Huggens College, College Road, Northfleet - GB/20240402

RE: KENT HIGHWAYS CONSULTEE COMMENTS

ADDITIONAL INFORMATION REQUEST

Application - GB/20240402

Figure A: Amended Pedestrian Connection

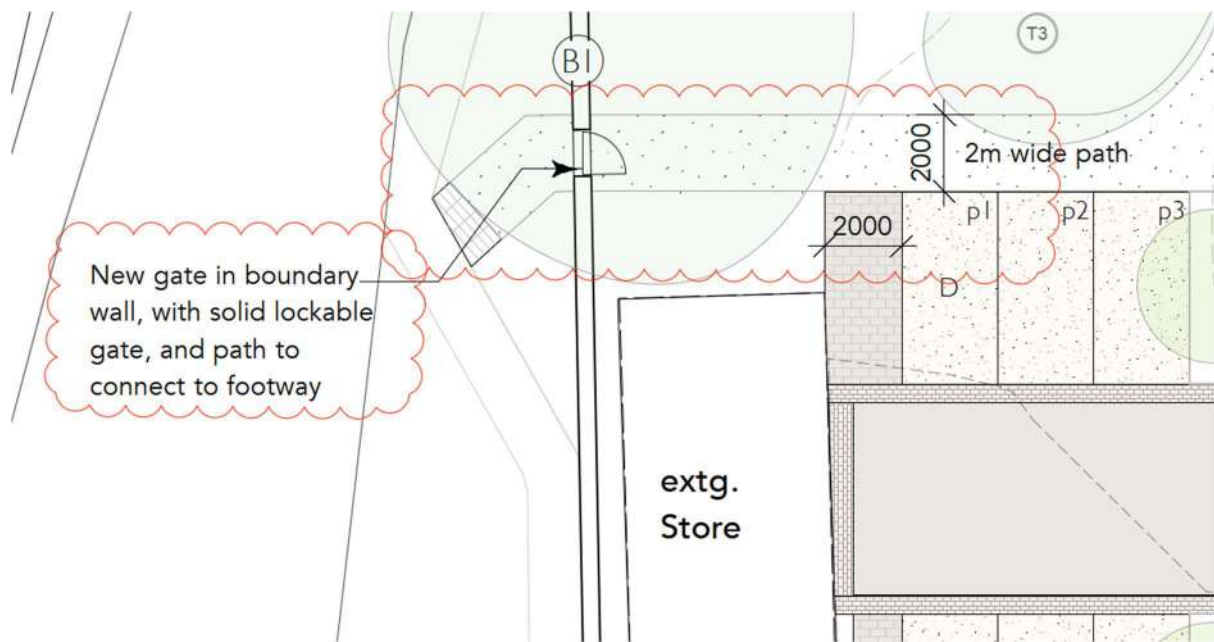
A new pedestrian entrance onto Stonebridge Road is proposed and is welcomed as this will enhance the permeability of the site. However, the access looks narrow and should be a minimum of 3m in order to allow cyclists to use it also. The plan does not show a footway/cycleway connection between the gate and the existing footway on Stonebridge Road (across the verge) and this must be shown on the plans in order to be conditioned.

The pedestrian access/egress will be secured by a gate. The expectation is that cyclists would most likely push their cycle to the gates to enter/exit.

The link between the proposed gate and the internal access road, a distance of approximately 10m, has been widened to 2 metres. This is considered acceptable for a private internal route which is lightly trafficked.

The amended arrangement is shown at **Figure B** which is an extract of the updated Site Layout Plan at **Appendix B**

HaysomWardMiller Architects		MASTERPLAN - Ground Floor Level	
20 Birge Street Cambridge CB2 1UF	Project	Almhouse Development	Job no. 23.709
T: 01223 578545	For	Huggens College	Drawing no. P 01
email: info@haysomwardmiller.co.uk	Scale	1:250 at A1 1:500 at A3	Revision no. E

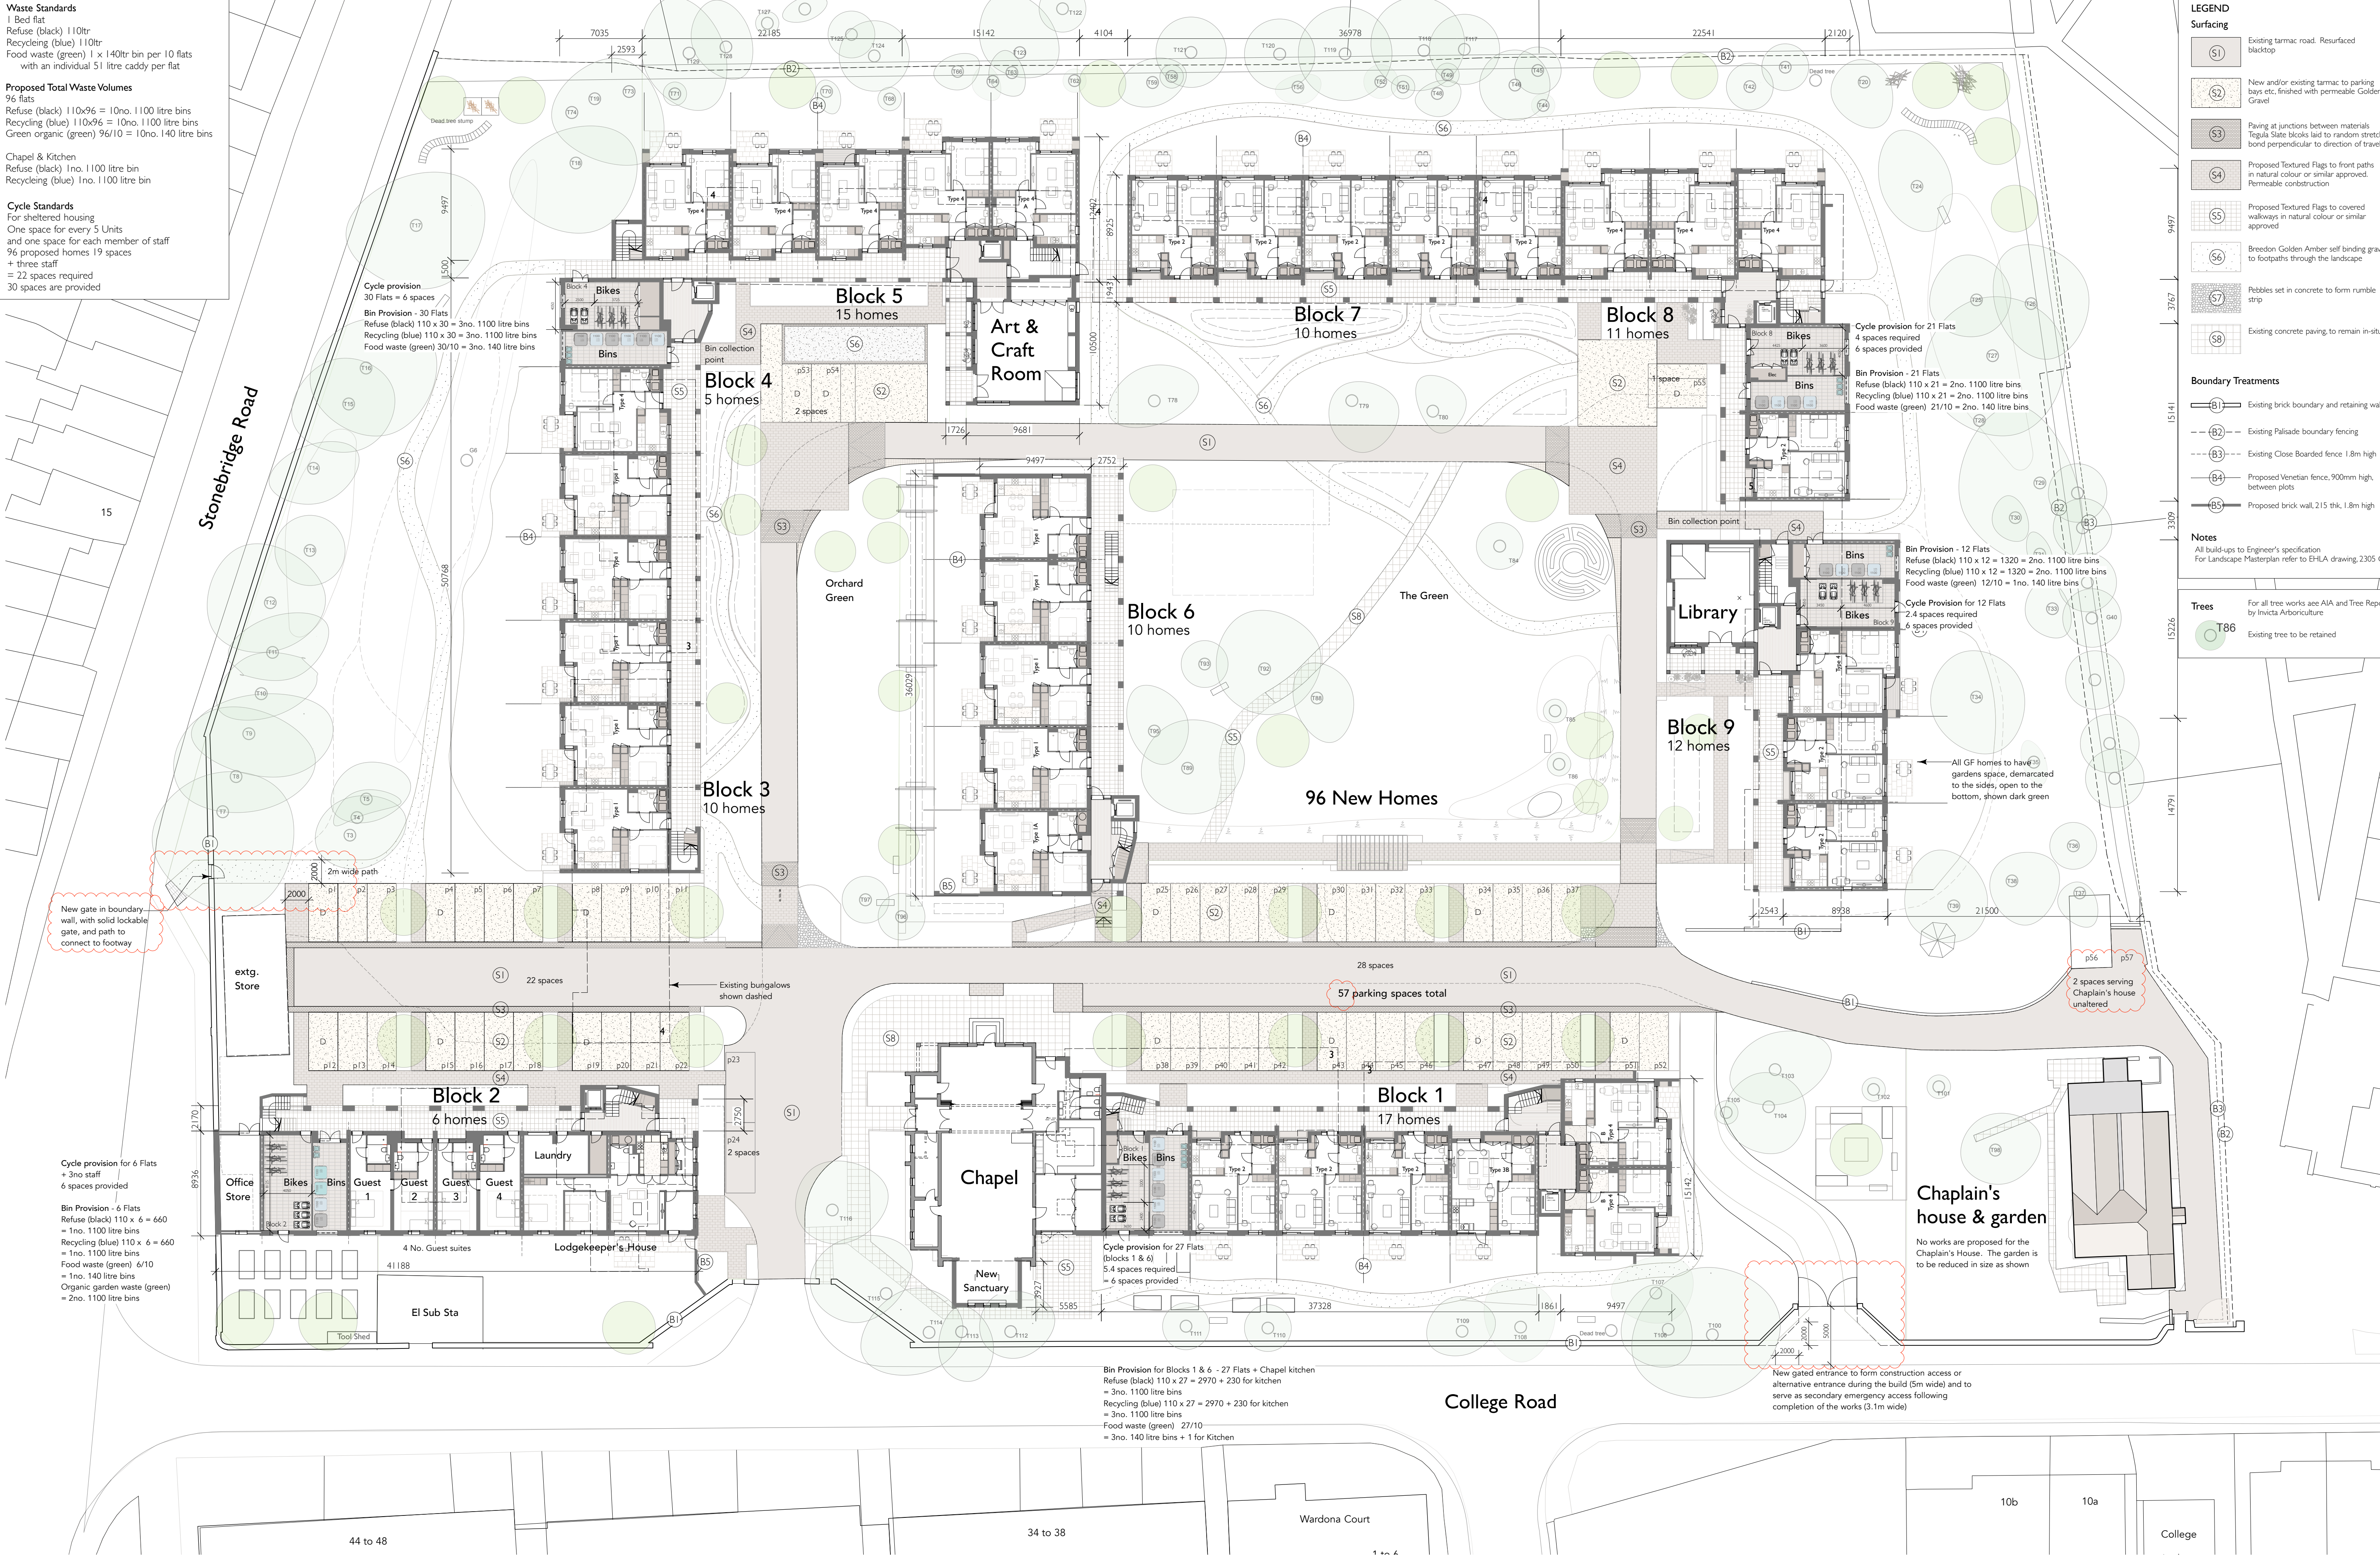
Please confirm how the access is to be secured for emergency use only, and show this on the plan.

- 2.1 An updated proposed development layout is included at **Appendix B** which shows the proposed access arrangements.

The emergency entrance will be secured by gates, as shown within the updated Site Layout Plan at **Appendix B**.

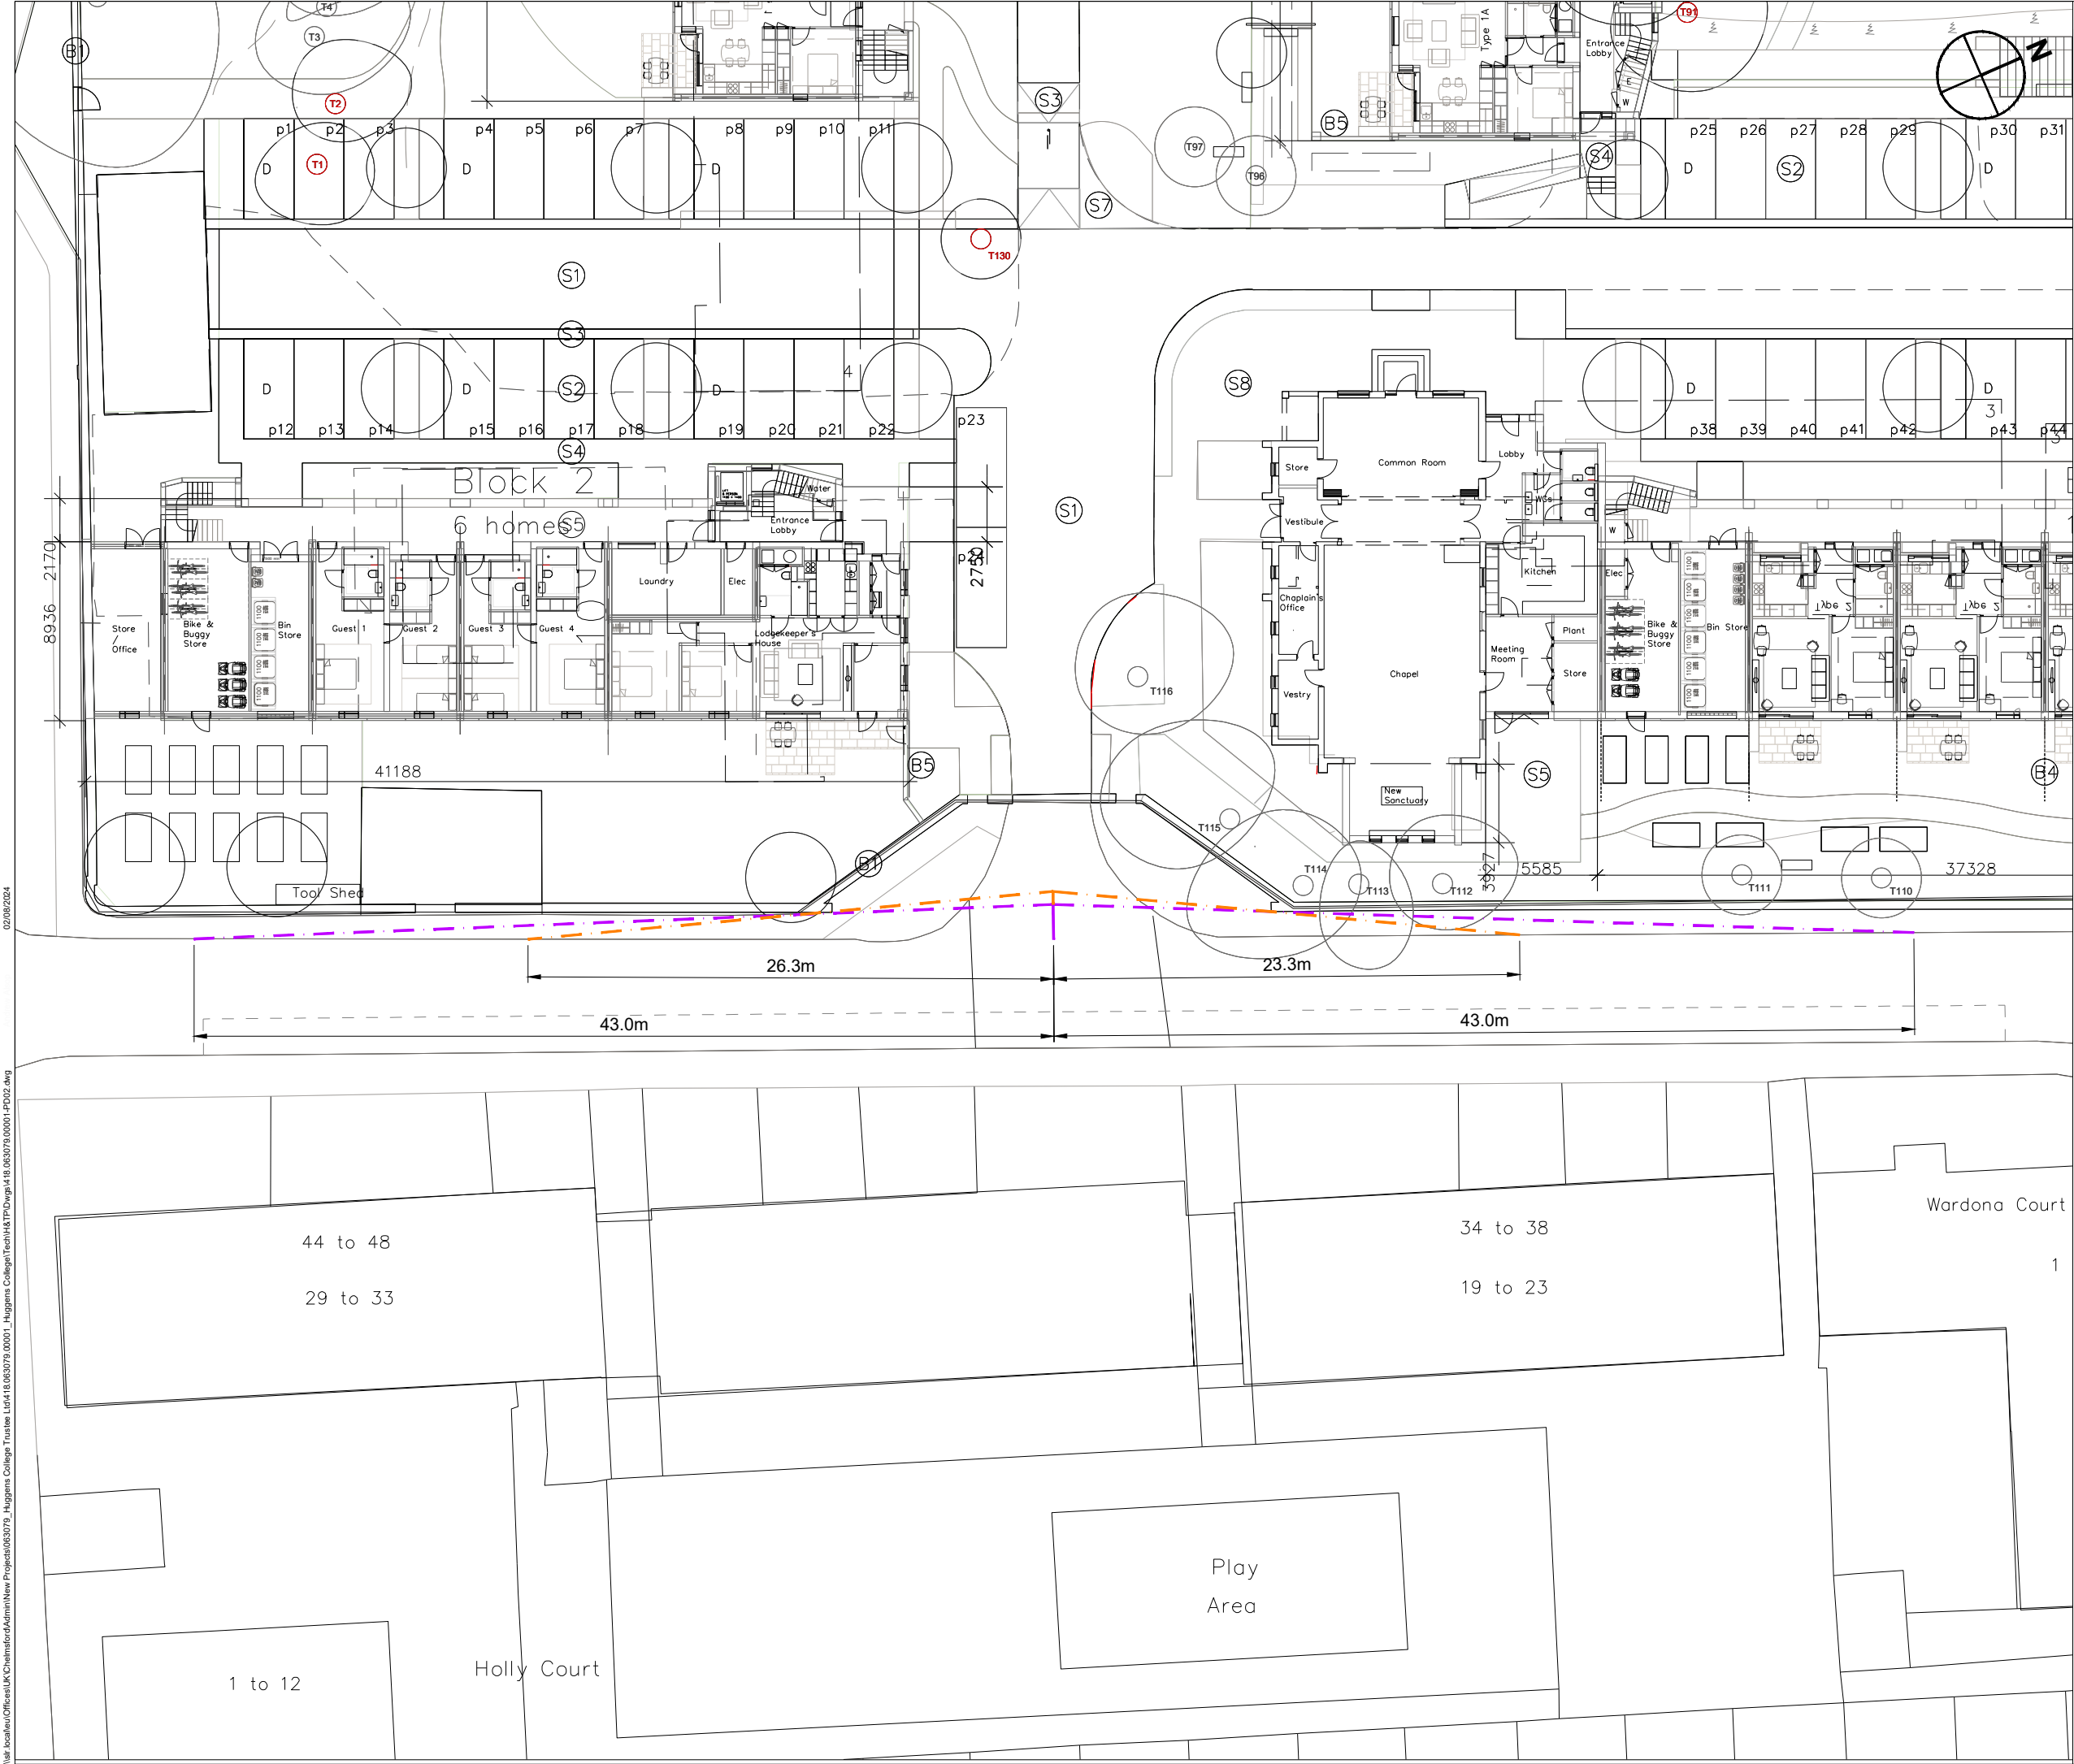
No visibility splays have been shown for the existing access, which will have an intensification of use. These should be shown on a plan.

Further consideration should be given to pedestrians entering and leaving the site via College Road. Are dropped kerbs provided on both sides of the bell mouth? Is the short section of footway from the pedestrian gate to the footway on College Road a minimum of 1.8m (ideally 2m)? The layout, dimensions and any required improvements should be shown on a plan.

The existing access serving is an established operational junction which operates without any safety or operation concerns. The proposals therefore include no changes to the existing layout.

It is expected that Site residents would use the pedestrian gate onto the B2175 Stonebridge Road.

A plan showing the current level of achievable visibility at the access junction is provided at **Appendix C**.
